ADDENDUM #2 TO BID #19-032

PROCUREMENT FOR: Beck Recreation Center Multi-Purpose Fields & Facilities

This addendum will amend **Bid #19-032, Beck Recreation Center Multi-Purpose Fields & Facilities** originally issued on Friday, April 26, 2019. This clarification is being provided to all known and registered correspondents in response to questions received. All addenda and original bid documents are also available online at: www.gtcounty.org, select Quick Links, "Bid Opportunities" and "Current Bids."

Title
UNDERDRAIN DETAIL
ADDENDUM #2

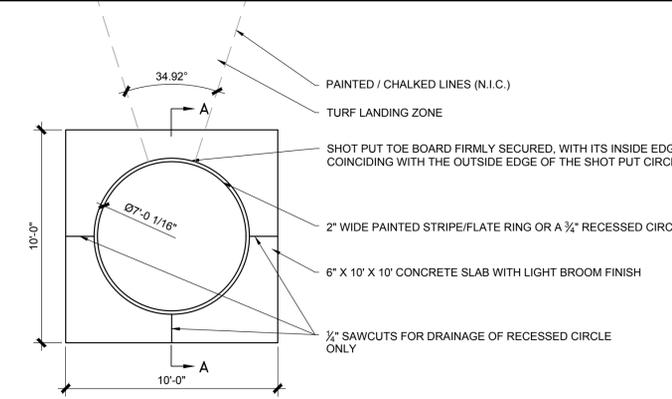
Question 20: The soil report recommends an undercut of 18-24. It also recommends underdrains and they are saying 6-12 inches of top soil? That's what the soil report says. What are we doing? Is it only after the proof roll or when does the undercut have to happen? See recommendations area of soil report. Does underdrains mean under asphalt, parking lots, etc?

An underdrain detail has been included and a line item added to the bid sheet unit price Exhibit H. Underdrains are not included in the base bid.

4 TRACK
SCALE: 1/2" = 1'

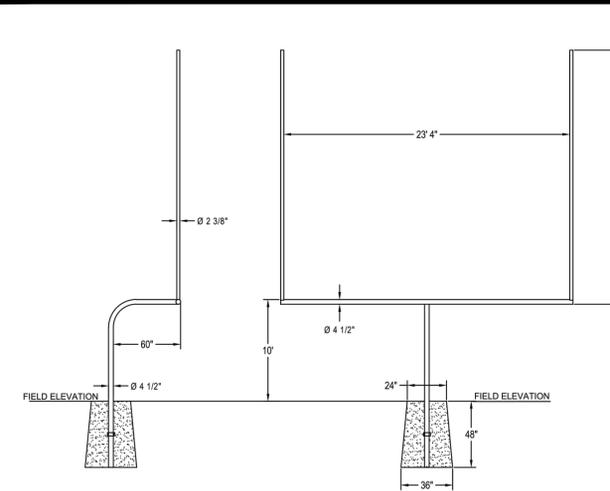
Question 14: What is the running track construction? Is there a section on the plans?

Question 15: What is the finish track surface?

Response: It is an asphalt track. See detail of track construction – updated detail #4 / Sheet C10.

Response: **The base bid is asphalt with painted lines. See alternates #2 and #3 for other surfaces.**
